**COMMENTS BY THE STATE OF NEVADA  
ON NRC's PROPOSED NEW LICENSING  
STANDARD FOR YUCCA MOUNTAIN**

**December 2005**

**Prepared by the Agency for Nuclear Projects  
Office of the Governor  
1761 E. College Parkway, Suite 118  
Carson City, Nevada 89706  
(775) 687-3744**

**Figure 1: TSPA-SR One-Million-Year Dose Histories for Nominal Case**  
(as Figure 12.1 of S Cohen & Associates, 2005, but reproduced from SSPA, Volume 2, Figure 3.1.2-1)

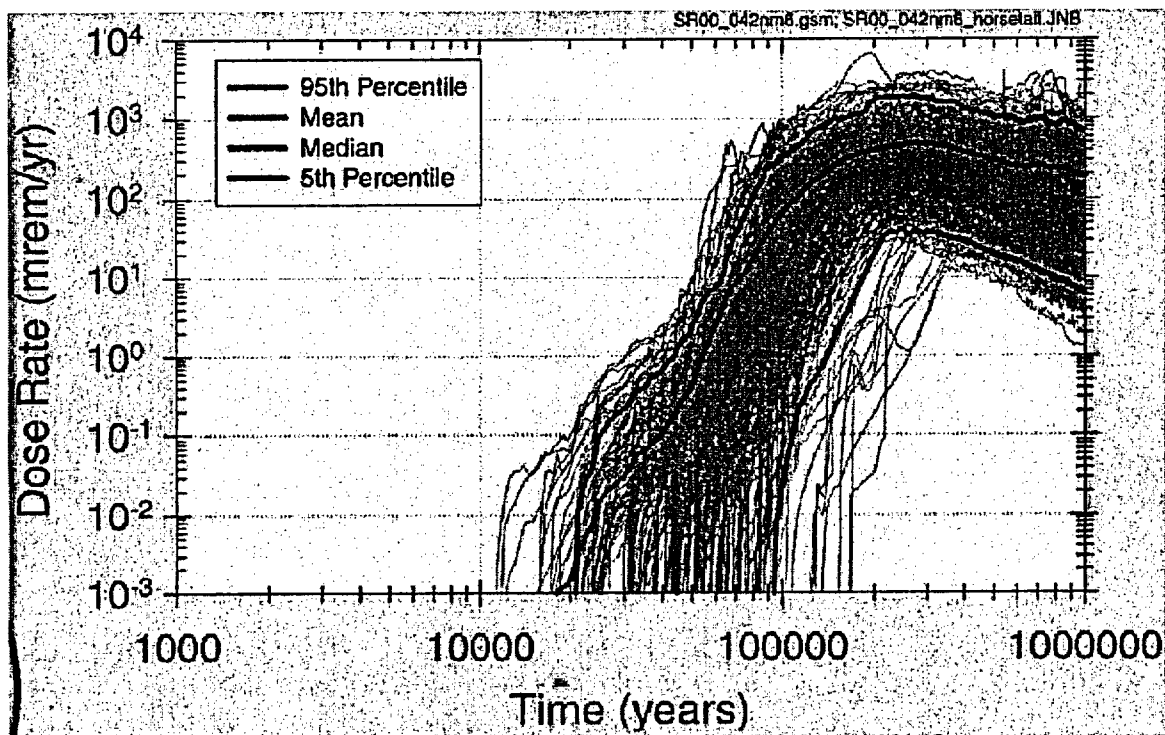
Figure 1 shows various statistical measures of the distribution. These are the arithmetic mean, median, and 5<sup>th</sup> and 95<sup>th</sup> percentiles. Results from the individual realizations are also shown. For the period up to 10,000 years, the EPA is proposing that the arithmetic mean value should be compared with a dose limit of 15 mrem, whereas beyond 10,000 years the EPA is proposing that the median value should be compared with a dose limit of 350 mrem. From Figure 1, it will be seen that the arithmetic mean value exceeds the median value at all times of interest and, in particular, at the time of peak dose. This result is general for any distribution that is positively skewed. The median value at any specific time is obtained by rank-ordering the results obtained from the individual realizations at that time and selecting the value of the mid-ranking result. Thus, if there were 300 realizations, the median would lie between the values of the 150<sup>th</sup> and 151<sup>st</sup> after they had been rank ordered by value. In contrast, the arithmetic mean is defined as the sum of all the results at a particular time divided by the number of realizations.

It should also be noted that 10,000 years does not represent a time at which there is necessarily a qualitative change in system performance. Thus, in Figure 1, the qualitative change occurs beyond 20,000 years. In Figure 3, there is no qualitative change and system performance remains much the same from 2,000 to 100,000 years. In Figure 5, the qualitative change occurs beyond 20,000 years, when early package failure becomes dominated by more general package failure.

**Figure 2: Relationship between the Median and Arithmetic Mean for a Positively Skew Distribution**

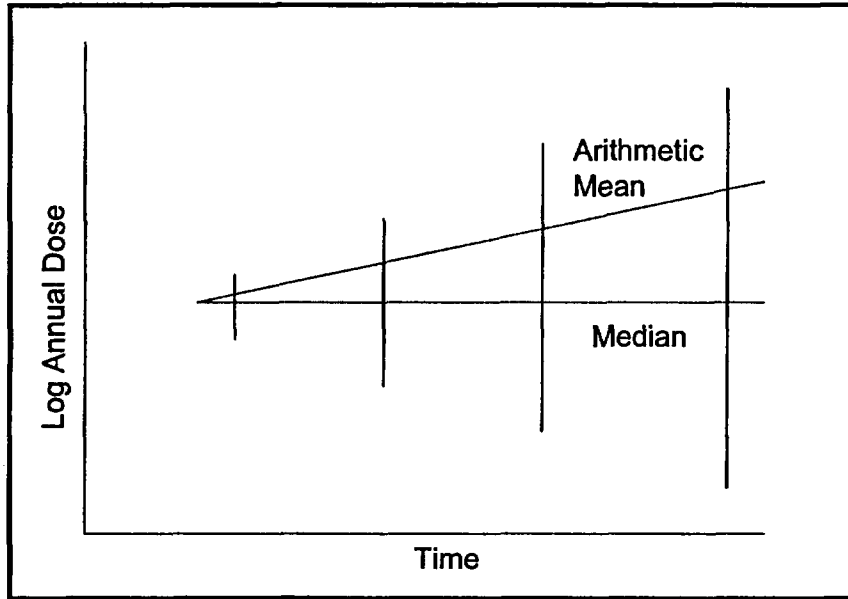
It should also be noted that if the median was used as a basis for compliance with a constant standard from the time of repository closure onward, an increase in uncertainty with time would not, in itself, necessarily result in greater difficulty in complying with the standard. However, for positively skew distributions, as typically occur in assessment studies, if the median remains constant in time and the uncertainty increases, the arithmetic mean will increase, so compliance with a constant standard will become more difficult with increasing uncertainty. This is illustrated in Figure 2.

Here a lognormal distribution underlies the range of variation at each time. As time increases, the range of variation increases, but because the range increases both to lower values and to higher values, the median can remain constant (imagine the vertical distance of each value from the median being multiplied by a constant scale factor greater than one as you move from one time to the next). Interestingly, the arithmetic mean value in this system does not remain constant, but increases, because it reflects the magnitudes of the individual values and not just whether they are above or below the median value. This distinction is general for positively skew distributions and can be quantified for particular examples. Thus, for the example of the commonly used lognormal distribution:

On this basis, the use of the median as a compliance measure diminishes the importance of changes in uncertainty with time relative to use of the arithmetic mean. However, it is not accepted that the uncertainty in performance at Yucca Mountain does increase substantially with time. This is demonstrated by a careful consideration of Figure 1. Both the median and 95<sup>th</sup> percentile can be seen at 50,000 years, where they differ by three orders of magnitude. At the peak, around 200,000 years, they differ by only one order of magnitude and this difference persists through to the end of the simulation.

**Figure 3: Figure 3.2.2-12 from Volume 2 of the SSPA, illustrating a Case with the Base Case Seepage Model and Neutralized Waste Packages and Drip Shields**

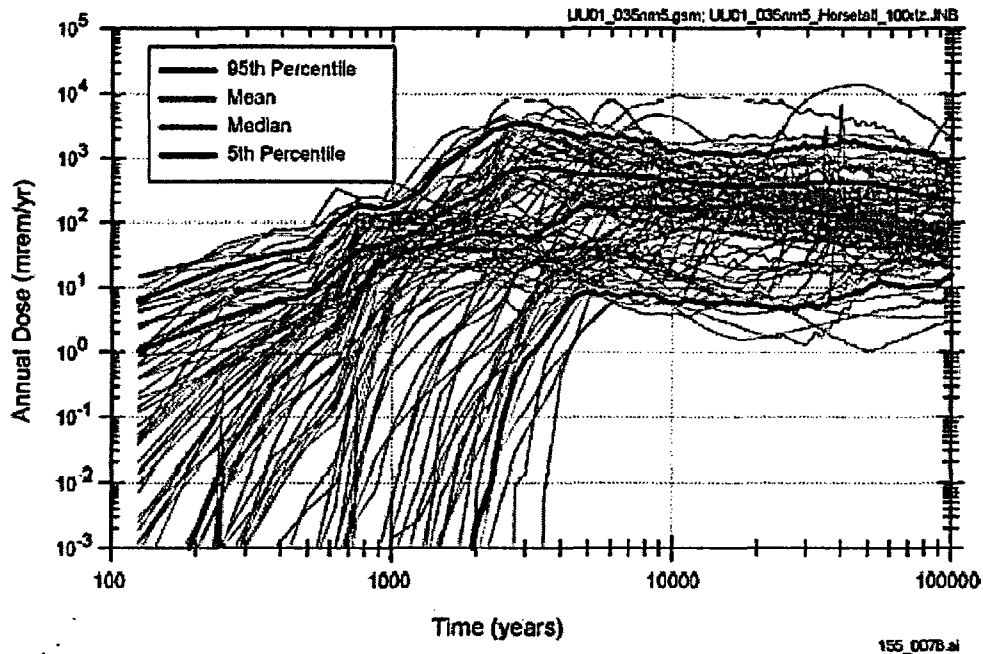
Note that, in this case, the uncertainty decreases until it reaches a fairly constant value from approximately 4,000 years onward.

**Figure 5: Figure 3.2.5.4-1 from Volume 2 of the SSPA, illustrating the Sensitivity of Annual Dose to Additional Uncertainty associated with Early Waste Package Failures due to Improper Heat Treatment**

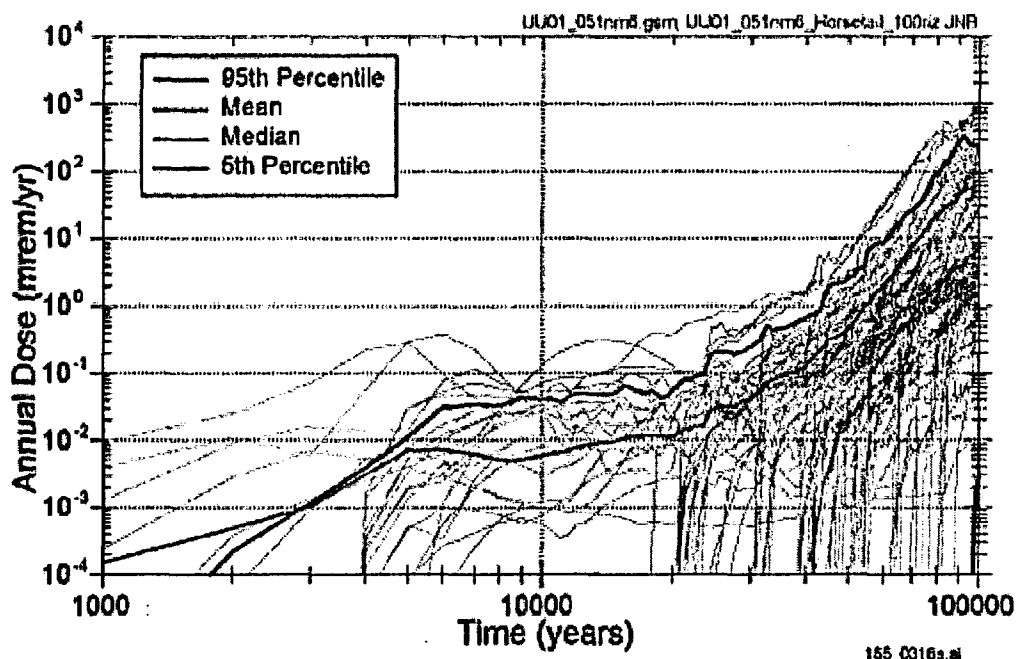
In Figure 5, the uncertainty to 40,000 years is very large (note that the median does not appear on the figure and the mean is higher than the 95<sup>th</sup> percentile over the first 2,500 years). Beyond 40,000 years there is a transition from a system dominated by releases from the waste packages that failed early to a system dominated by more general waste package failure. Beyond that time, as it becomes increasingly likely that the majority of the packages have failed, the uncertainty range decreases and, by 100,000 years, the difference between the median and the 95<sup>th</sup> percentile is only about a factor of twenty.

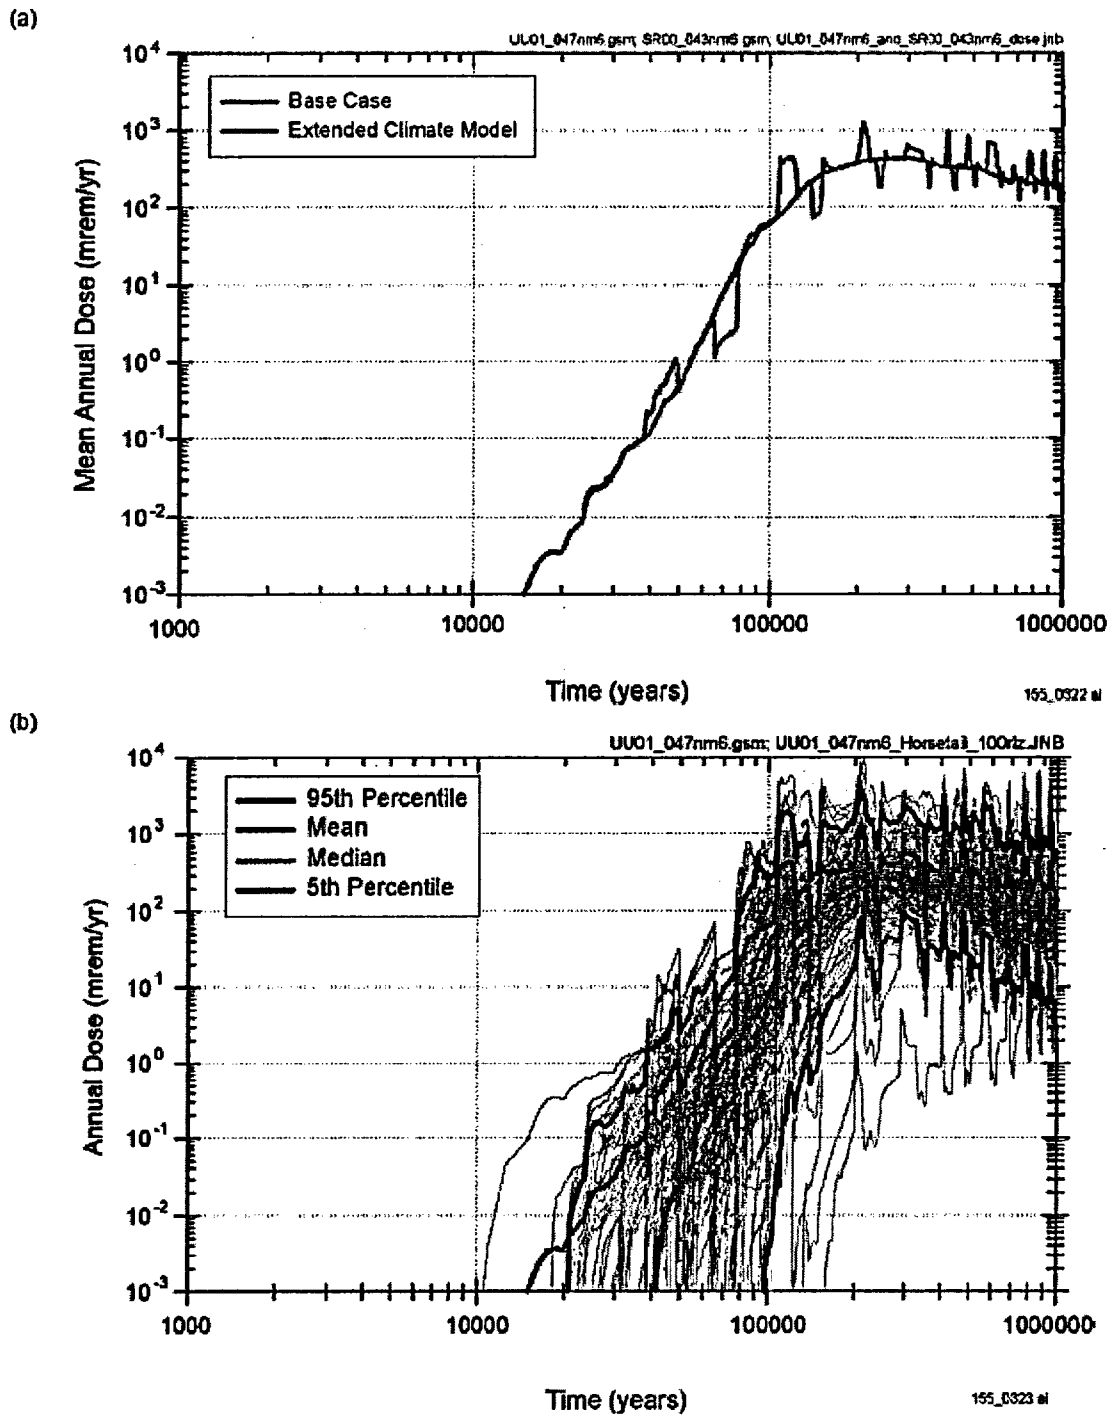
Finally, on this point, we note that Figure 3.2.1-1 from Volume 2 of the SSPA (2001) (reproduced below as Figure 1) demonstrates that annual doses assessed using the TSPA can respond very rapidly to changes in climate. In a study in which the times of climate transitions were fixed for every realization, the changes in response arose almost instantaneously in nearly all those realizations. As a basis for interpreting this figure, it should be noted that, in the Extended Climate Model, there is no change in climate state from 2,000 years to 38,000 years, which is when the first glacial period (increased infiltration) is estimated to occur. The next glacial period occurs at 106,000 years and 200,000 years. Glacial periods are 8,000 to 40,000 years in duration and recur approximately every 90,000 years, on average.
